AUSTRALIAN RAIL TRACK CORPORATION LTD
APPLICATION TO VARY THE HUNTER VALLEY COAL NETWORK ACCESS
UNDERTAKING (VARIED ON 17 OCTOBER 2012) TO PROVIDE FOR THE
INCORPORATION OF GAP TO TURRAWAN SEGMENTS IN THE NETWORK

CONFIDENTIAL RESPONSE TO ACCC INFORMATION REQUEST

17 SEPTEMBER 2013

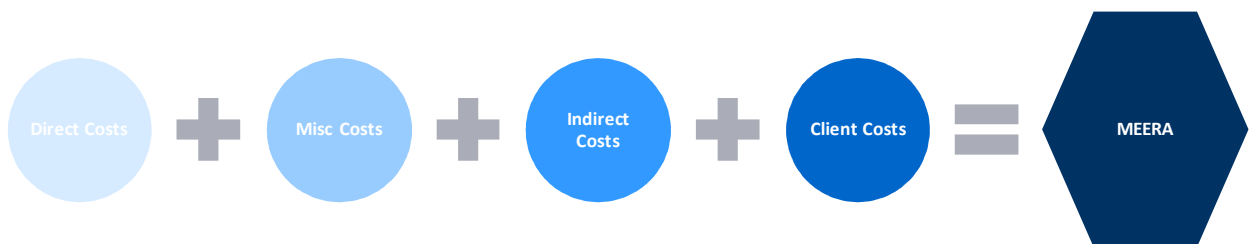
How has Evans & Peck ensured that costs are not ‘double counted’ in applying the mark-ups to reflect indirect costs and client costs? For example, how has Evans & Peck ensured that installation costs are not included in both the direct and indirect costs? What cost allocation methodology was used to inform the magnitude of indirect cost and miscellaneous cost mark-ups attributable to particular assets where a contractor would undertake multiple projects for ARTC and others?

As detailed in Section 4.3 of the Report, Evans & Peck has developed and applied a MEERA pricing model consisting of four components (Contractor’s Direct Costs, Miscellaneous Costs, Contractor’s Indirect Costs and Client Costs) as displayed below.

Each component has elements grouped and allowed for within it, as follows:

- **Contractor’s Direct Costs** – labour, plant, equipment, materials and subcontract works.
- **Miscellaneous Costs** – costs not covered within the Direct Costs, typically environmental controls, safety, existing services survey, pre-condition survey, temporary works, etc.
- **Contractor’s Indirect Costs** – preliminaries and design, as well as overhead and margin.
- **Client Costs** – delivery agency costs, insurance.

This clearly defined pricing structure ensures that there is no double counting in applying the mark-ups to the assets.
